APPEAL SUMMARY

Appeal ID: 31979	Project Address: 4626 SE Clinton Street
Hearing Date: 11/15/23	Appellant Name: Tanya Wuertz
Case No.: B-010	Appellant Phone: 303.883.8309
Appeal Type: Building	Plans Examiner/Inspector: Chanel Horn
Project Type: Commercial	Stories: 3 Occupancy: Group R-2 Construction Type: Type V-A
Building/Business Name: Peaceful Villa - Clinton Street Building East	Fire Sprinklers: Yes - as required per NFPA 13
Appeal Involves: Erection of a new structure	LUR or Permit Application No.: 23-035596-CO
Plan Submitted Option: pdf [File 1] [File 2]	Proposed use: Residential Apartments

Code Section	2022 OSSC Section 1011.7.4 Enclosures under exterior stairways.
Requires	"1011.7.4 Enclosures under exterior stairways. There shall not be enclosed usable space under exterior exit stairways unless the space is completely enclosed in 1-hour fire-resistance-rated construction. The open space under exterior stairways shall not be used for any purpose."
Code Modification or Alternate Requested	The purpose of this appeal is to allow two mailbox units to be located as shown under the exterior exit stairway in the east breezeway of the Clinton East Building.
Proposed Design	Egress

52 FLOOR PLAN LEVEL 01 SECTOR A
1/8" = 1'-0"

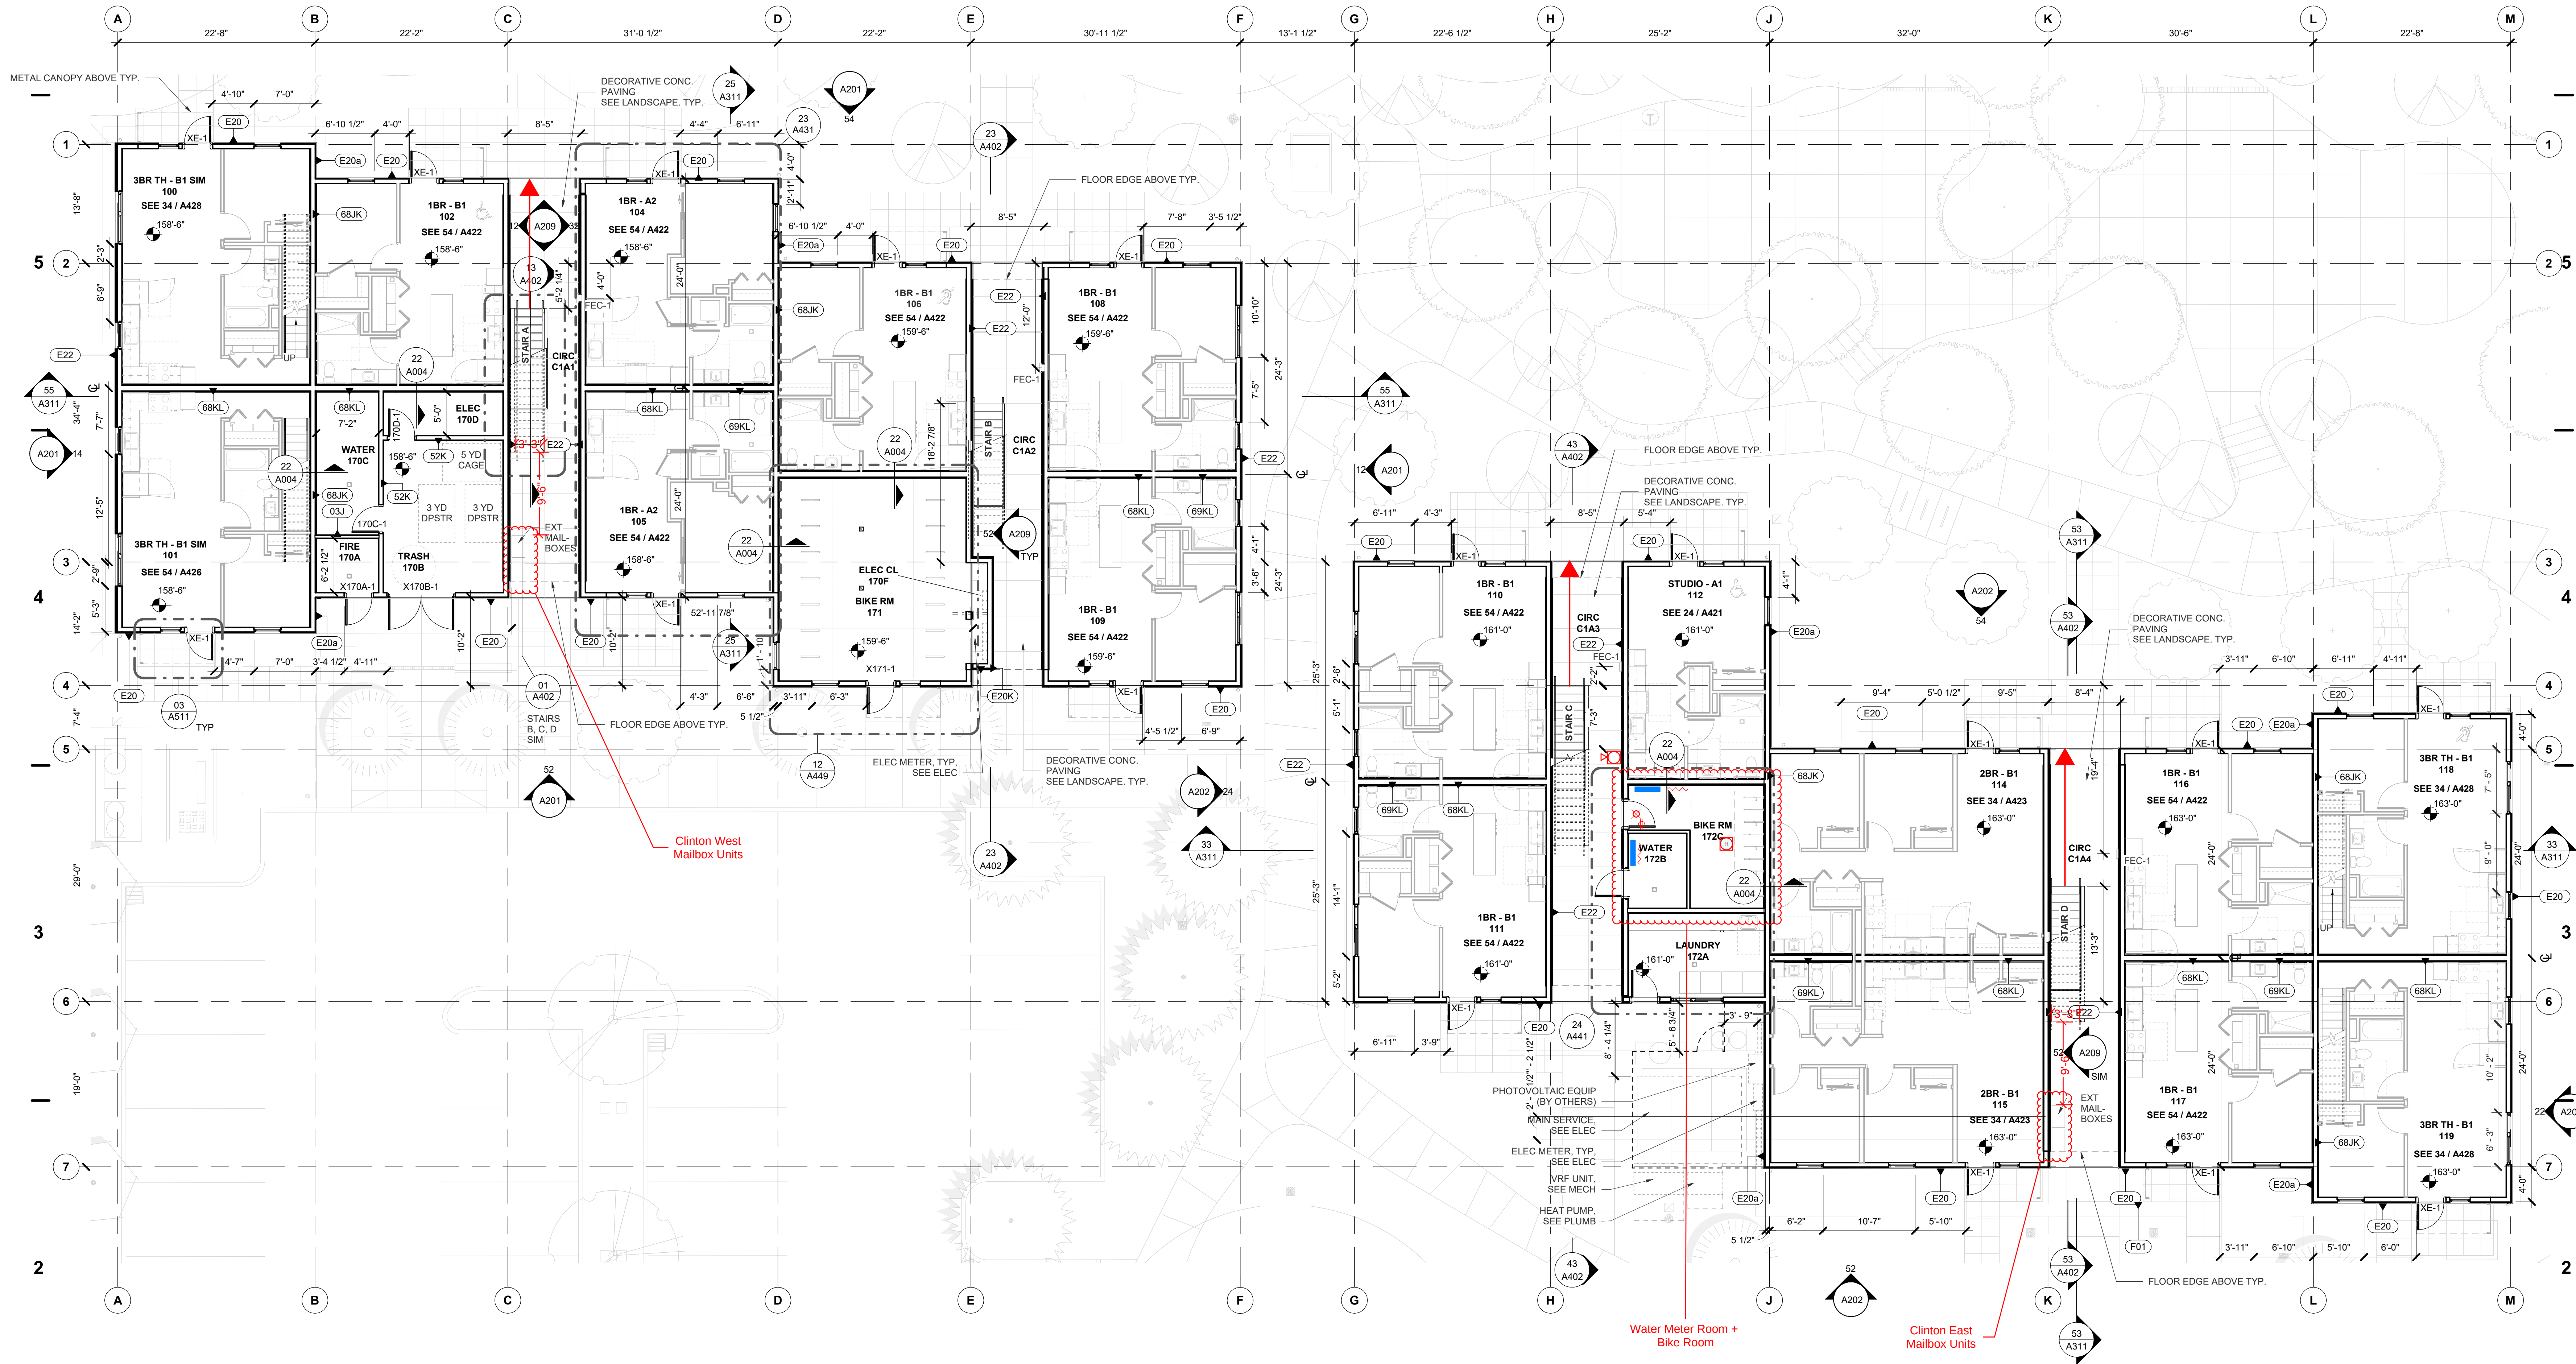
- Non-combustible as they are made of metal; mail is segregated into small compartments.
- Only one, small parcel compartment (10 inch parcel, 10 inch x 12 inch door).
- Prescriptively, within the breezeway, there are dry, side-wall sprinkler heads.

The mailbox units are located at the end of the breezeway that is opposite from the direction of egress. Additionally, the breezeway is open on two ends, where an exit stairway is only required to be open on one side per Section 1027.3. The openings located on two opposite sides will allow for cross-ventilation and encourage smoke movement, should smoke enter the breezeway from the conditions identified as part of this appeal.

The mailbox units are located in the breezeway, outside the footprint of the stair in plan; they are located within the area defined as the exterior exit stairway. However, the mailboxes are constructed of metal and noncombustible. They are divided into small compartments to hold the mail of residents. This does not contribute significantly to combustible loading or fire origination due to the protection and division of the mail by the mailbox design. Other than the single parcel compartment, any large packages will be handled by a parcel locker located outside of the

breezeway. Additionally, due to the prescriptive installation of dry sprinkler heads in the breezeway, a fire would quickly be suppressed, if not extinguished, should a fire originate in the breezeway. Egress could still be maintained as the egress path runs north, opposite of the mailbox location on the south end.

Per Section, 1011.7.4, the open space under exterior stairways shall not be used for any purpose. However, due to the minimal fire risk of the mailboxes due to noncombustible materials, individualized compartments with secured access, and limited combustible loading, it is proposed that the strategies presented provide equivalent fire and life safety protection for occupants and the exterior exit stairway path should a fire/smoke event occur involving these mailbox units.

Therefore, it is requested to allow the mailbox units at the Clinton East building as identified in the Proposed Design.

Location of two mailbox units within the exterior exit stairway of the Clinton East Building: Granted as proposed.

The Administrative Appeal Board finds that the information submitted by the appellant demonstrates that the approved modifications or alternate methods are consistent with the intent of the code; do not lessen health, safety, accessibility, life, fire safety or structural requirements; and that special conditions unique to this project make strict application of those code sections impractical.
